Amendments to the Drawings:

REMARKS/ARGUMENTS

Fig. 3a

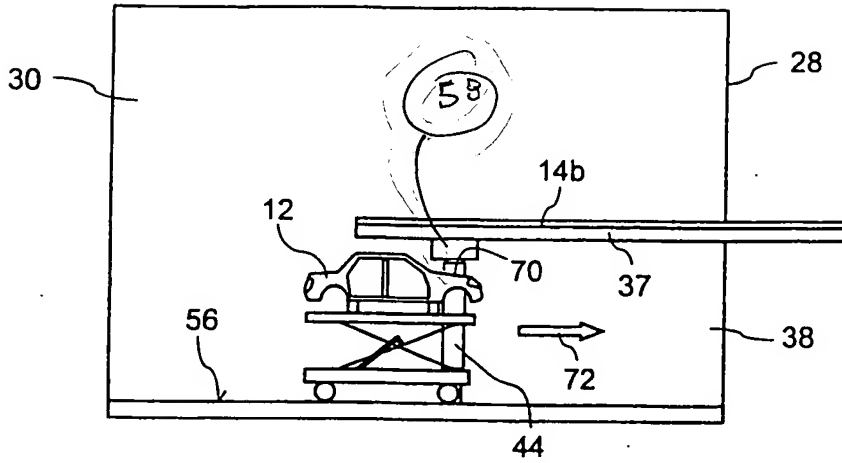
The attached sheet of drawings includes changes to Figs. 3a-3c. This sheet, which includes Figs. 3a-3c, replaces the original sheet including Figs. 3a-3c. In Figs. 3a-3c, previously unidentified roof radiator is identified with added reference numeral 58.

Figs. 3a-3b have been amended to identify the roof radiator with the reference numeral 58, which was inadvertently omitted from the drawings. Support for the roof radiator 58 can be found throughout the specification as originally filed, most notably at paragraphs 74-76 of the published application. As such, no new matter has been added.
